C15-2015-0011
Row 11269461
Roll/TAX 010303021
(TEAD V)

**CITY OF AUSTIN APPLICATION TO BOARD
OF ADJUSTMENT INTERPRETATIONS
PART I: APPLICANT'S STATEMENT
(Please type)**

STREET ADDRESS: 904 Jessie Street, Austin TX 78704

TO: Board of Adjustment
FROM: Daniel Word, Planner Principal, Residential Review
DATE: December 31, 2014
SUBJECT: Appeal of Building Permit Approval at 904 Jessie Street

EXHIBIT A

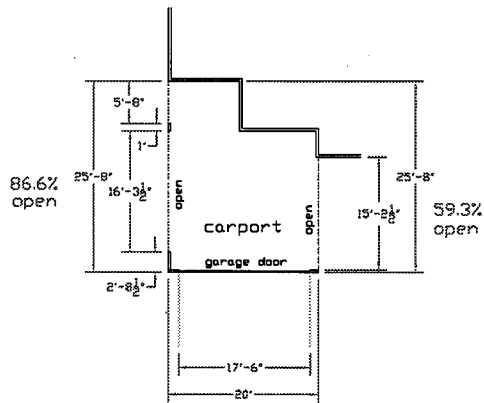
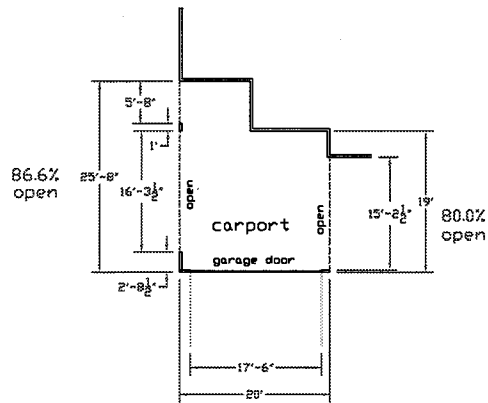
- a) The applicant is utilizing an L-shaped carport, which creates issues in calculating the percentage of the opening on the north side of the carport. ZNA believes utilizing an L-shaped carport allows one to misinterpret the intent of the ordinance and circumvent it. There is no real question as to the length of the opening. However, there is a difference of interpretation with respect to the overall length of the wall needed to calculate the percentage of the opening. There are three ways one might calculate the overall length of the north wall as shown in Exhibit A. The applicant is utilizing Method 2 although some applicants are even arguing for the use of Method 3. ZNA believes Method 1 is the correct way to calculate the opening. Using this method, the opening is only 59.3%. Using Method 2, the opening is almost exactly 80%. Please note that the applicant calculates the opening percentage using Method 2 to be 81.3% as shown on Drawing A3.1. This is because the applicant incorrectly uses an overall length of 18'-8½" instead of the actual 19' as shown on the first floor plan in Drawing A1.1.

ZNA believes it is a misinterpretation of the ordinance to not require the overall measurement along the full length of the entire carport. The problem associated with using Method 2 is illustrated more fully in Examples 1 through 6 of Exhibit B. As part of the internal carport wall shifts from Example 1 to Example 6, it becomes more and more obvious that the overall length of the wall opening should be measured using Method 1. If one were to accept the use of Method 2, then it must be decided at which point (from Example 1 to Example 6) that the measurement of the overall length should be switched to Method 1 rather than Method 2.

EXHIBIT B

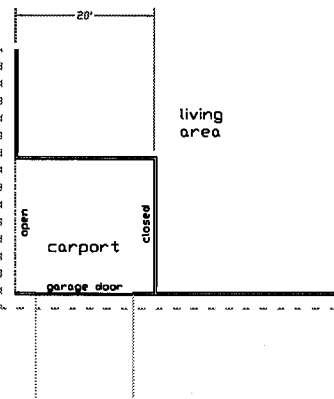
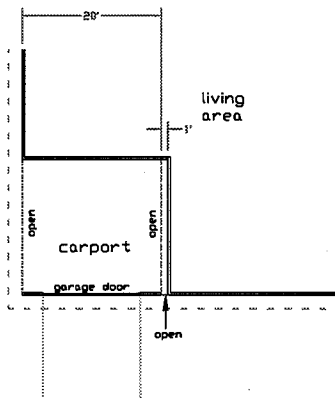
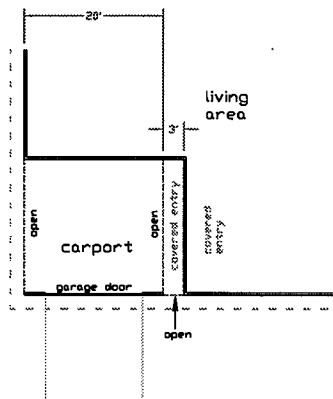
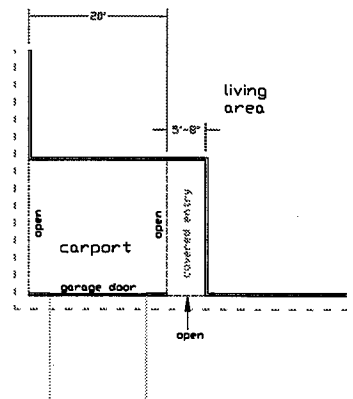
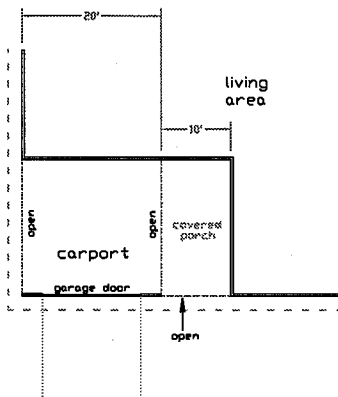
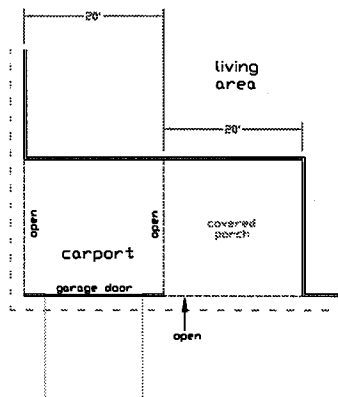
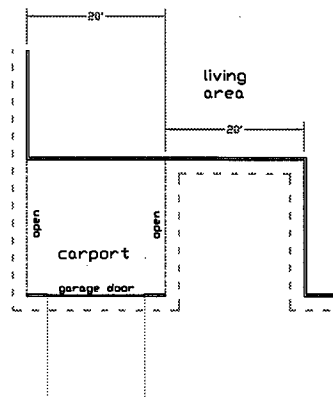
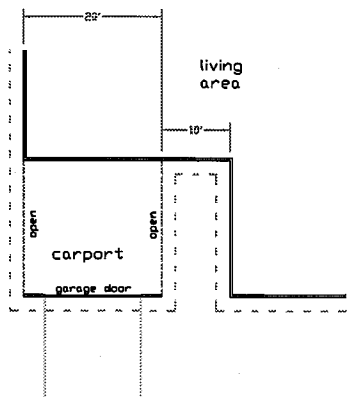
- b) The applicant is claiming that the north side of the carport is clear and unobstructed. ZNA believes that an assertion that a carport opening is clear and unobstructed when it is immediately adjacent to an enclosed and covered entry way is not only inconsistent with the plain wording of the ordinance, it is completely inconsistent with the intent of the ordinance. Since the ordinance grants only a 200 sq ft exemption for an enclosed parking area, we believe that the clear and unobstructed wall openings required by the ordinance were specifically intended to prevent the additional mass that would be created by constructing an enclosed parking area (i.e., a garage) to the front of a house. The idea was that an open carport could qualify for the larger 450 sq ft exemption because this type of parking area would not seem so massive. The applicant for 904 Jessie, as well as other applicants, are attempting to use the carport exemption to essentially allow construction of something that very closely resembles an enclosed garage. ZNA does not believe the carport exemption was ever intended to allow garage doors on carports. However, the ordinance does seem to permit this as the current project demonstrates. What the ordinance does not permit, and should not be interpreted to permit, is for the "carport" to become even more similar to a garage by allowing one side of it to be completely enclosed with an entry way that is itself also enclosed and covered.

Exhibit B illustrates possible examples of parking areas that are adjacent to covered and enclosed entry ways. ZNA believes that Examples 1 through 6 are instances where the carport opening is not clear and unobstructed. We believe Examples 7 and 8 are acceptable under the current wording of the ordinance.

A1.1

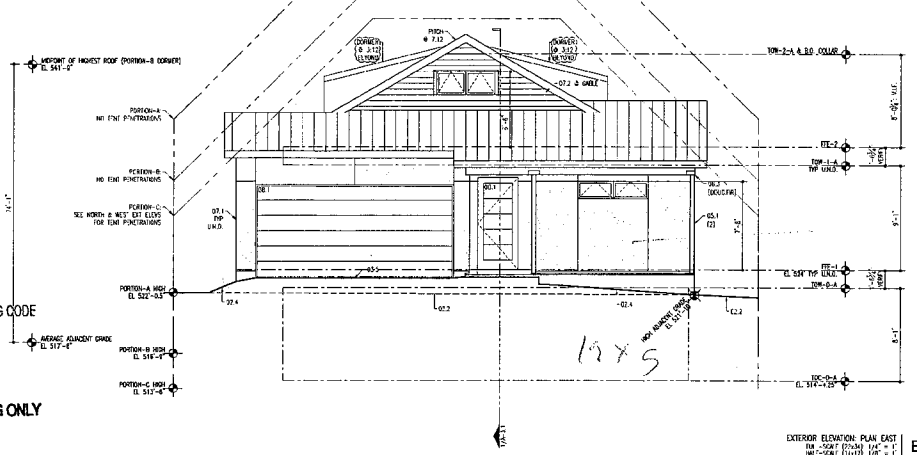
The architectural plans of the first and second floor are drawn to the outer edge of the wood framing and not to the "outside surface of the exterior walls" which is demonstrated by the fact that the first floor plan dimensions match the foundation plan dimensions. Normally, the edge of the framing is aligned with the foundation edge. When sheathing and siding are added, this dimension is typically increased by more than an inch on all sides. Since the criteria for calculating the McMansion FAR is measurement to the "outside surface of the exterior walls", the McMansion FAR is not calculated correctly. If one assumes a ½" sheathing and ¾" siding, the first floor area is increased 22.9 sq ft and the basement floor area is increased by 10.3 sq ft. This is an additional 33.2 sq ft that must be added to the McMansion FAR calculation. Using AutoCAD and the applicant's dimensions, ZNA calculated an area of 1,893.0 sq ft for the first floor and 968.9 sq ft for the basement floor as measured to the edge of framing, for a total of 2,861.9 sq ft. Adding the additional 33.2 sq ft for the area from the edge of framing to the outside surface of the exterior wall makes the total FAR 2,895.1 sq ft. This is 40.17% or 12.7 sq ft over the maximum limit of 40%. The gross floor area contained in the floor plans must be reduced to comply with the LDC.

Regarding the first issue, staff concurs with the position of the appellant that gross floor area measurements should be taken to the "outside surface of the exterior walls" as written in the code, which in the opinion of staff, should include exterior finishes, inclusive of masonry, siding, stucco or other materials. Staff respectfully requests the Board uphold the appeal and require the construction plans be corrected to comply with the interpretation of both staff and the appellant as it relates to the calculation of gross floor area.

EXHIBIT A

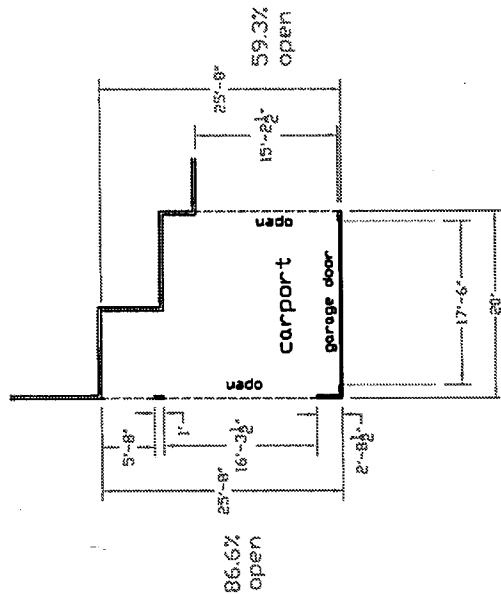
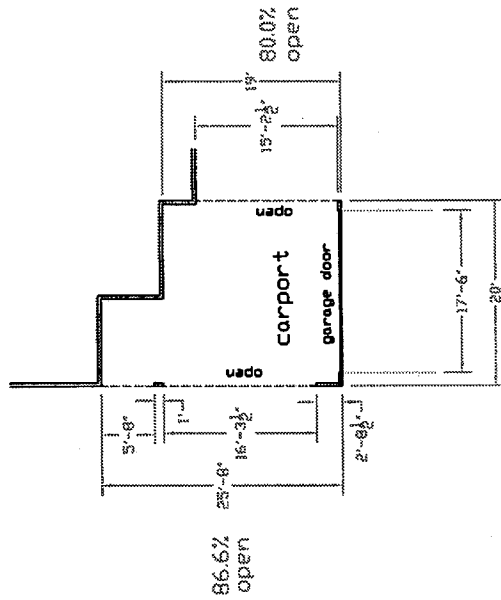
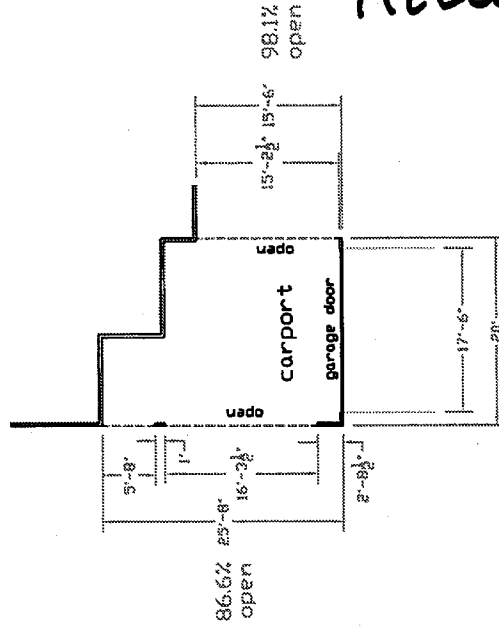
- a) The applicant is utilizing an L-shaped carport, which creates issues in calculating the percentage of the opening on the north side of the carport. ZNA believes utilizing an L-shaped carport allows one to misinterpret the intent of the ordinance and circumvent it. There is no real question as to the length of the opening. However, there is a difference of interpretation with respect to the overall length of the wall to be used in calculating the percentage of the opening. There are three ways one might calculate the overall length of the north wall as shown in Exhibit A. The applicant is utilizing Method 2 although some applicants are even arguing for the use of Method 3. ZNA believes Method 1 is the correct way to calculate the opening. Using this method, the opening is only 59.3%. Using Method 2, the opening is almost exactly 80%. Please note that in using Method 2, the applicant calculates the opening percentage to be 81.3% as shown in Drawing A3.1. This is because the applicant incorrectly uses an overall length of 18'-8½" instead of the actual 19' as shown on the first floor plan in Drawing A1.1.
